STAFF RECOMMENDATION
2018 10th Avenue South
(formerly 2020 10th Avenue South)
June 20, 2018

Application: New construction—infill
District: Waverly-Belmont Neighborhood Conservation Zoning Overlay
Council District: 17
Map and Parcel Number: 10509047900
Applicant: William Smallman
Project Lead: Melissa Sajid, melissa.sajid@nashville.gov

Description of Project: Application is to construct infill on a vacant lot.

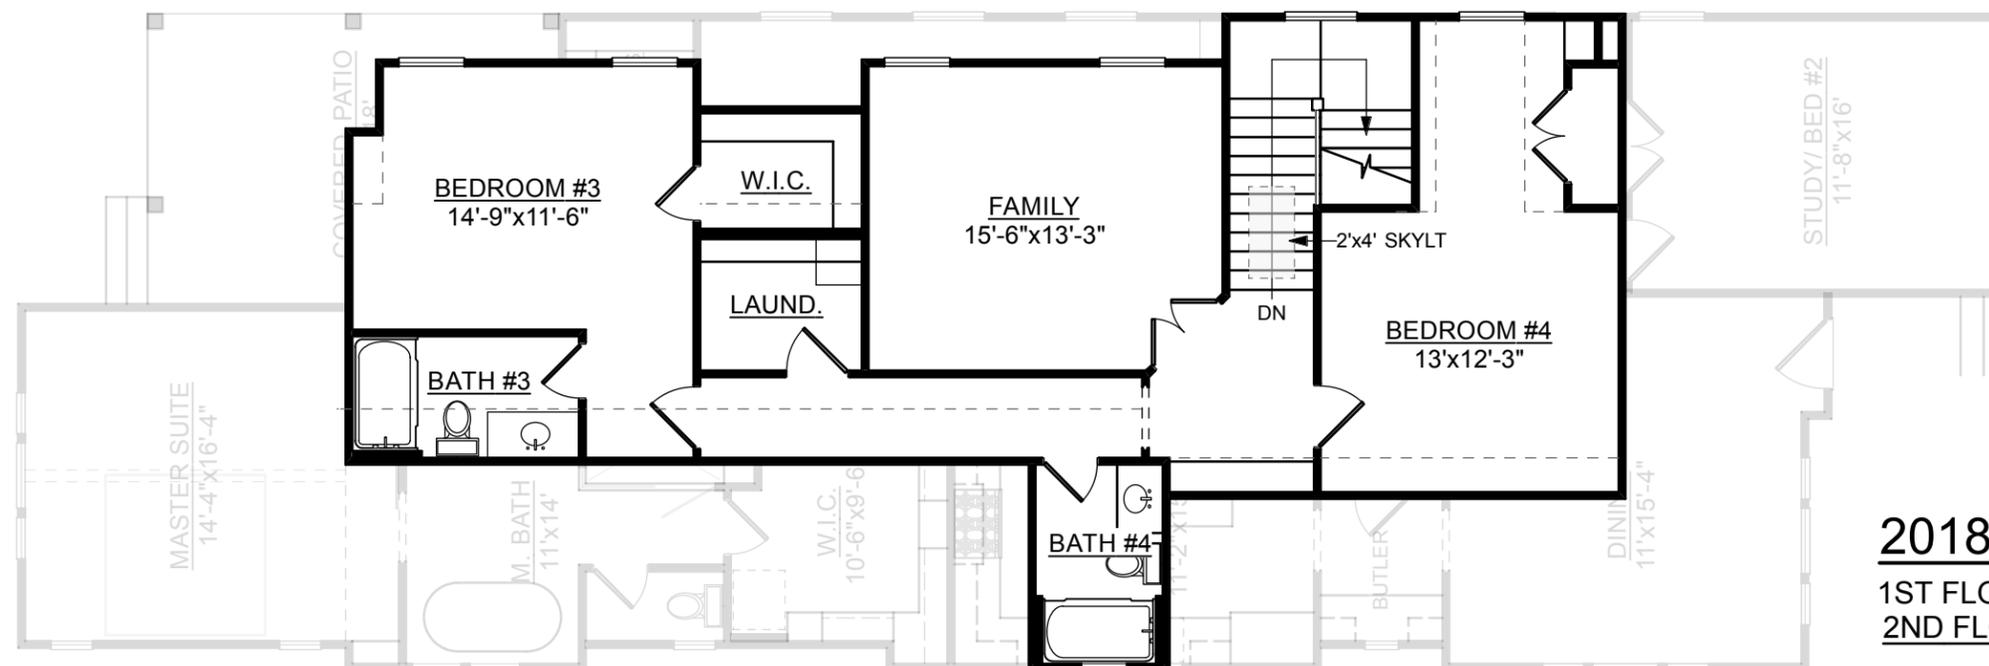
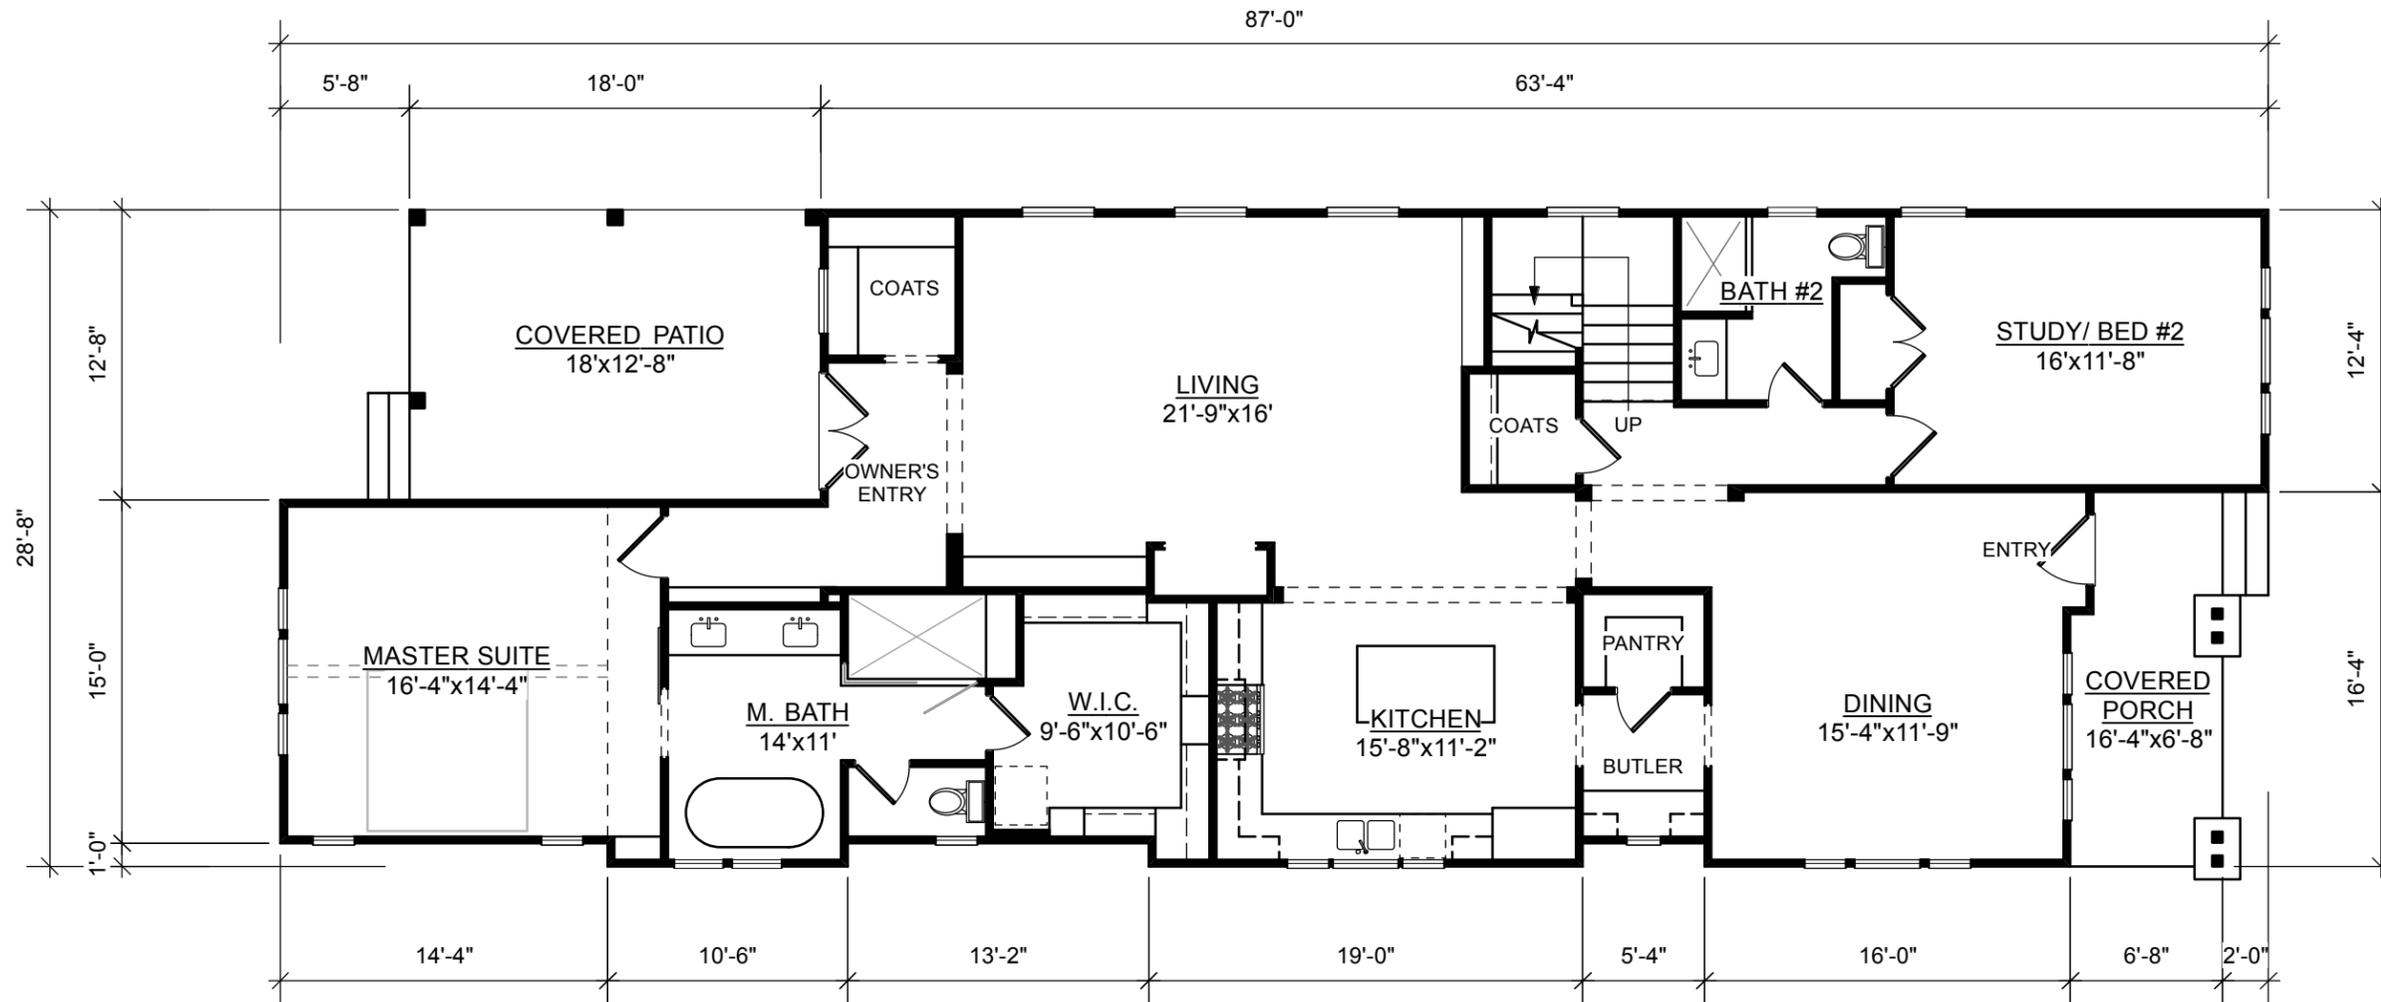
Height & Scale: The proposed house is one-and-a-half stories but will read as a single-story house at the front. The maximum height will be twenty-eight feet, six inches (28'-

6”) from grade; however, the maximum height is only a small portion of the roof given the pyramidal roof form. The form and height of the infill is compatible with the surrounding historic houses, which are primarily single-story but includes one historic house that is one and one-half stories with heights between twenty-one feet and twenty-eight feet (21’ – 28’).

Roof form: The project incorporates pyramidal and gabled roof forms, which are common for the historic context. Both the pyramidal form as well as most of the gables will have a pitch of 12/12. The plan includes a shed dormer on the right side façade with a pitch of 3.5/12. Although a pitch of 6/12 is typical for the neighborhood, dormers and porches often had shallower pitches, historically.

Proportion and Rhythm of Openings: The majority of the windows on the infill are generally twice as tall as they are wide, thereby meeting the historic proportions of openings. The right side and rear façades each include a smaller square window. Staff

finds the two square windows to be appropriate as they are unlikely to be visible from the street given their locations. Staff finds the project's proportion and rhythm of openings can meet Section III.G. of the design guidelines.

SITE PLAN
2018 10TH AVE S

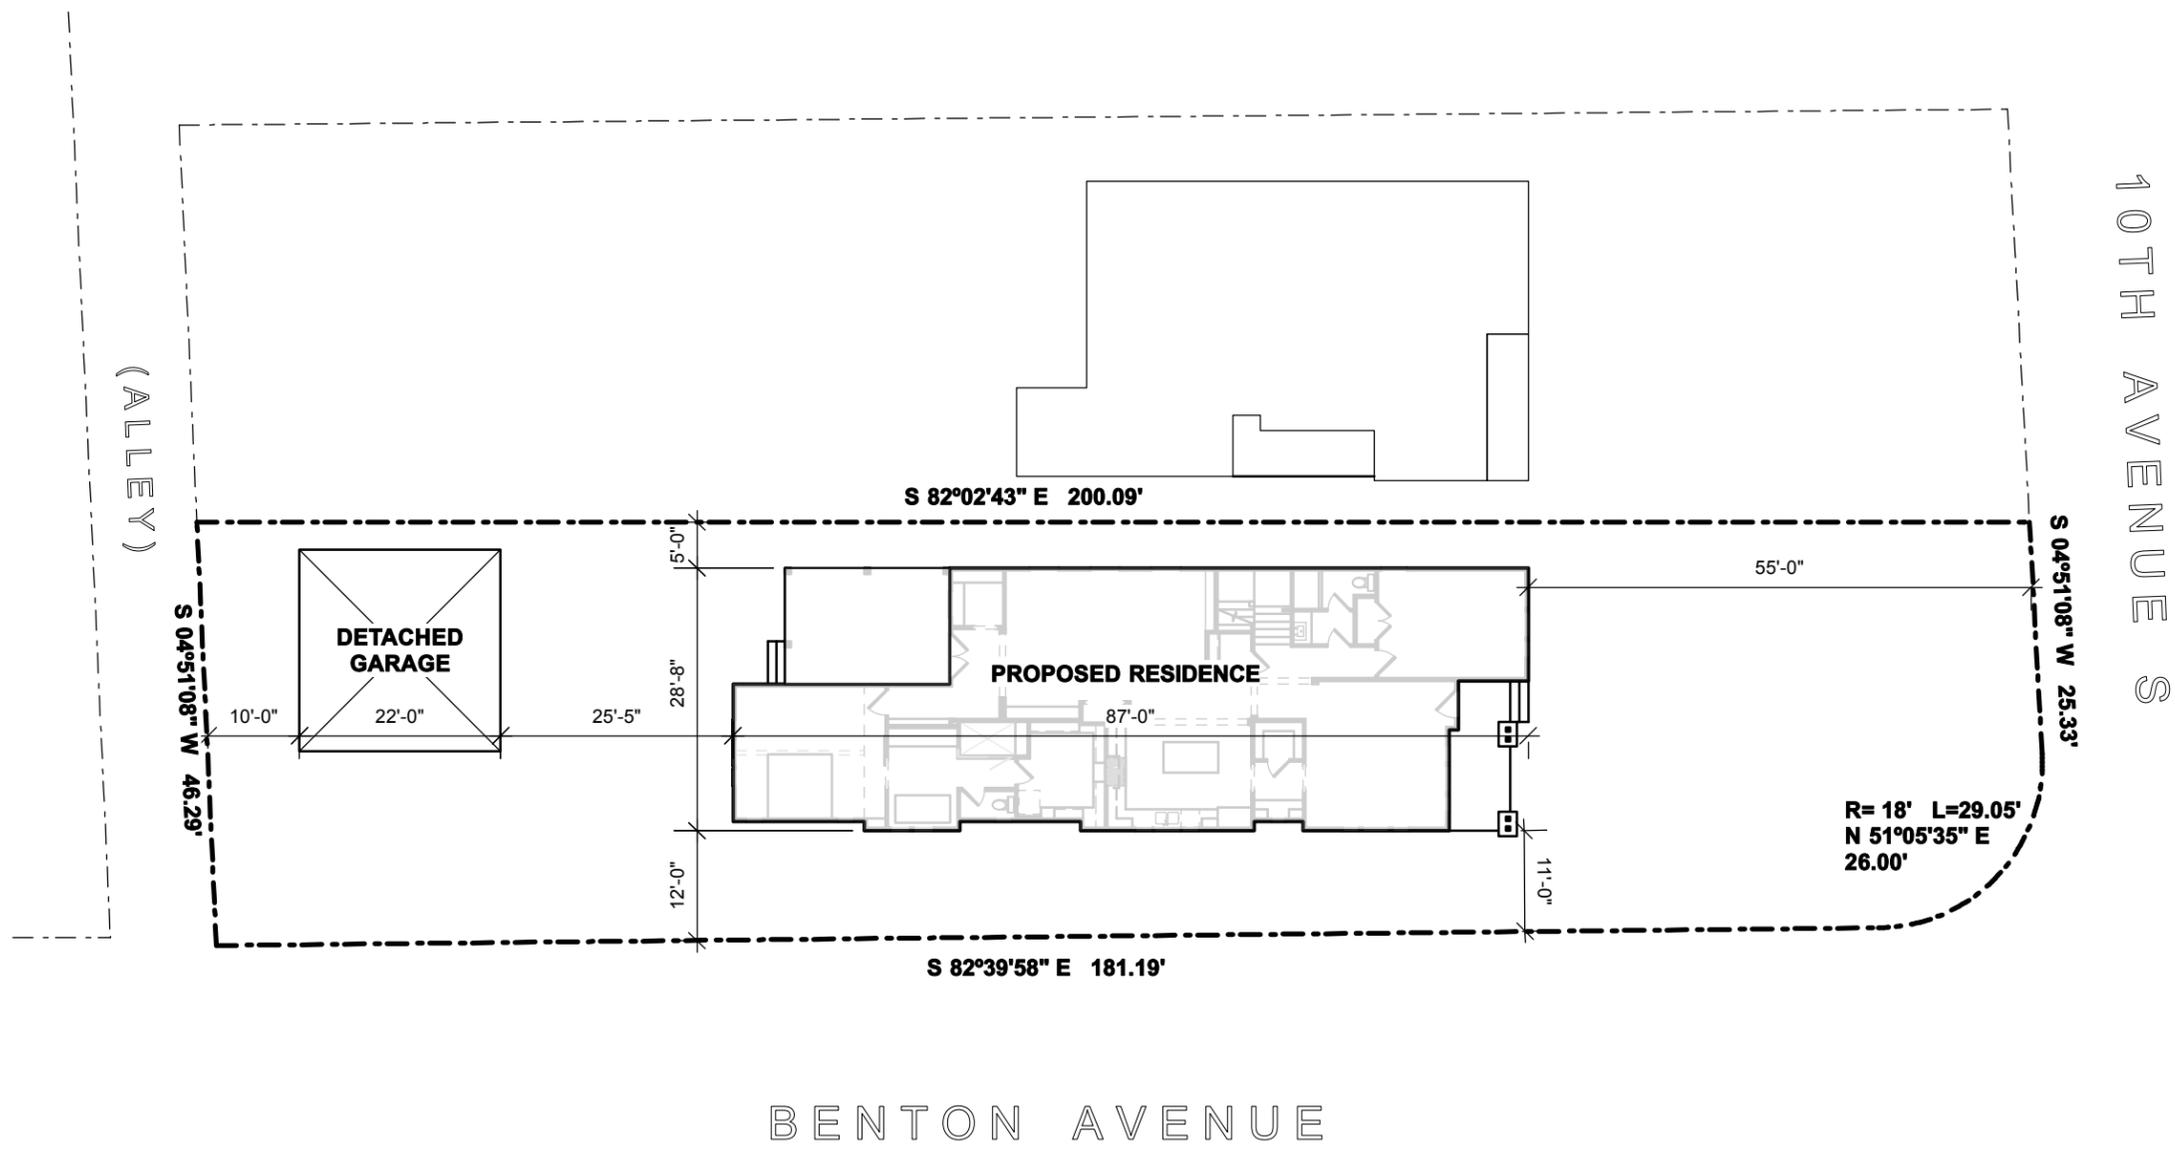
Setback & Rhythm of Spacing: The proposed infill meets all base zoning setbacks. The infill will be situated fifty-five feet (55’) from the front property line, which is similar to front setback of the historic house next door at 2020 10th Avenue South. The house will be setback eleven feet (11’) from the left side property line along Benton Avenue. The right side setback will be five feet (5’), and the rear setback will be approximately fifty-seven feet (57’).

Orientation: The house is oriented towards 10th Avenue South, which is appropriate. The entrance faces the street and is located behind a six foot, eight inch (6'-8") deep partial-width front porch. Staff recommends that a front walkway, leading from the front porch to the sidewalk, be included on the site plan. Vehicular access to the site is not indicated on the plan, but staff recommends that it be from the alley. With conditions that vehicular access be from the alley and that a walkway from the front porch to the sidewalk be shown on the plan, staff finds that the infill's orientation meets Section III.F. of the design guidelines.

1. The finished floor height shall be consistent with the finished floor height of the adjacent historic house, to be verified by MHZC staff in the field;
2. The front setback shall be consistent with the buildings to either side, to be verified by MHZC staff in the field;
3. The site plan shall incorporate a walkway leading from the front porch to the public sidewalk;
4. Vehicular access shall be from the alley;
5. Staff shall review and approve all materials prior to purchase and installation; and
6. The HVAC shall be located behind the house or on either side, beyond the midpoint of the house.
